# ODI RESUME

**Investigation:** EA 16-002  
**Prompted by:**  
**Date Opened:** 02/03/2016 **Date Closed:** 06/24/2016  
**Investigator:** Stephen Mchenry **Reviewer:** Jeff Quandt  
**Approver:** Stephen Ridella  
**Subject:** Vehicle rollaway, engine on

**Manufacturer:** Chrysler (FCA US LLC)  
**Products:** 2014-15 Grand Cherokee; 2012-14 Charger & 300 w/3.6L engine  
**Population:** 811,586  
**Problem Description:** Drivers may exit the vehicle when the engine is running and the transmission is not in Park, resulting in unattended vehicle rollaway. Rollaway incidents may result in serious injuries to the driver or passengers as they exit the vehicle or to other pedestrians in the path of the rolling vehicle.

**Figure 1. Monostable gearshift, 2014-15 Jeep Grand Cherokee.**

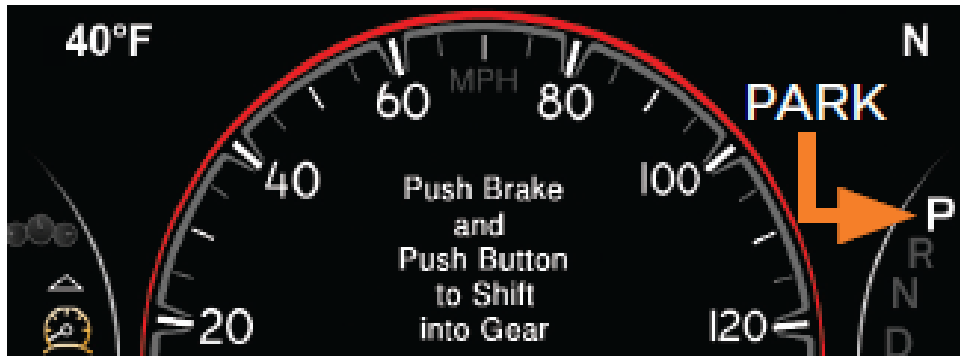
The vehicles recalled by FCA are equipped with Monostable electronic ("shift-by-wire") gearshift assemblies supplied by ZF Group (see Figure 1). The subject Monostable shifter has a single neutral position that it snaps back to when the driver releases the shift knob. Although the Monostable gearshift has the familiar appearance of a conventional console mechanical gearshift assembly, it has an unfamiliar movement that does not provide the tactile or visual feedback that drivers are accustomed to receiving from conventional shifters. Consequently, the driver must take additional time to verify that the desired gear position was achieved by checking the PRNDL display on the shift knob or the Electronic Vehicle Information Center (EVIC) display.

FCA received negative consumer feedback for the Monostable shifters shortly after the subject vehicles entered the market. Field data indicate that the design resulted in higher error rates during attempted shifts to Park and higher rates of powered rollaway incidents. The Monostable design appears to violate several basic design guidelines for vehicle controls,<sup>1</sup> such as: 1) be consistent; 2) controls and displays should function the way people expect them to function; 3) minimize what the user has to remember; and 4) operations that occur most often or have the greatest impact on driving safety should be the easiest to perform. FCA changed to Polystable electronic gearshift assemblies in MY 2015 Charger/300 cars and MY 2016 Jeep Grand Cherokee vehicles (see Figure 2). The Polystable gearshift assemblies stay in the position of the selected gear, similar to a standard mechanical shifter, providing drivers with the expected tactile and visual feedback (i.e., works as expected and does not require additional thought or attention).
